<small>STANDARD 1000          200 500 1000 1500          LBA-NO. 301-33-8</small>	Modification number 25 Aircraft type H 301 "Libelle"	Page 1 Number of Pages 2
---	---	-----------------------------

Description: Locking guide for elevator assembly  
 Drawing -No. 301-33-8

Höhenruder-Montagesicherung  
Horizontal Tail Assembly Guide

Änderung  
Nr. 25  
Blatt 2

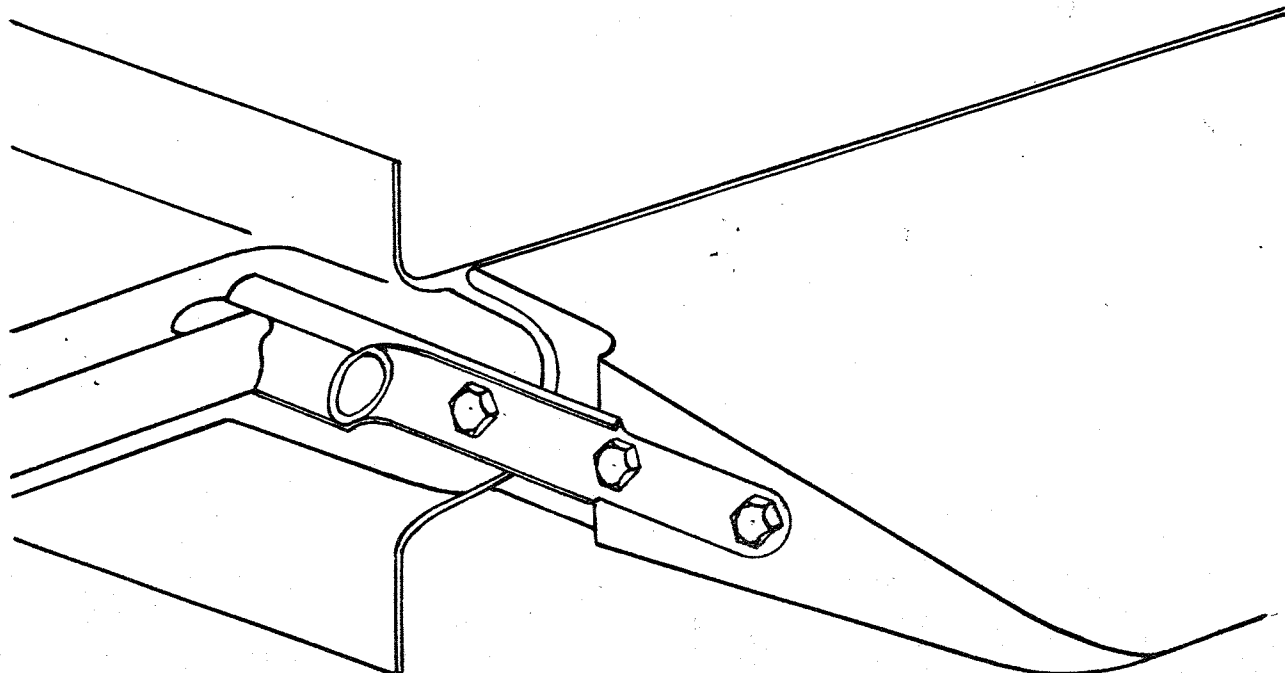
Inserting horizontal tail into fin, an improper assembly is possible. The installation of elevator locking guide prevents this.

Elevator locking guide must be installed on the left or right side of horizontal stabilizer in accordance with page 2 of modification. Drawing and parts may be obtained from GLASFLÜGEL, ING. EUGEN HÄNLE, 7311-SCHLATTSTALL/WTTBG./GERMANY

Remove both front bolts of elevator main fitting and take care, that washers on both sides of the ball bearing don't drop.

Reinstall elevator locking guide and fitting according to page 2.

Test-assembly!

Now check the guide when assembled for freedom of operation.

Teilansicht des Höhenleitwerks, R-Höhenruder-Hauptbeschlag  
sectional view of horizontal stabilizer, RH-elevator-main fitting

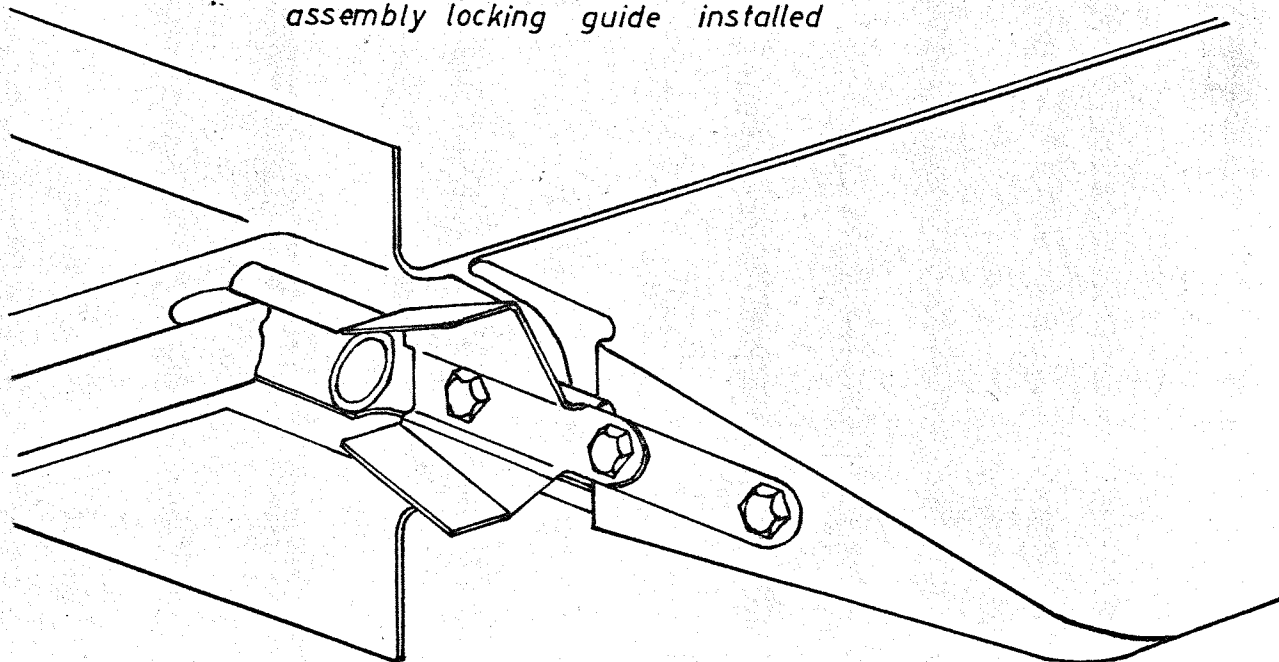
Ausführung bis Werk-Nr. 85  
construction through serial-number 85

Sicherung eingebaut!  
assembly locking guide installed
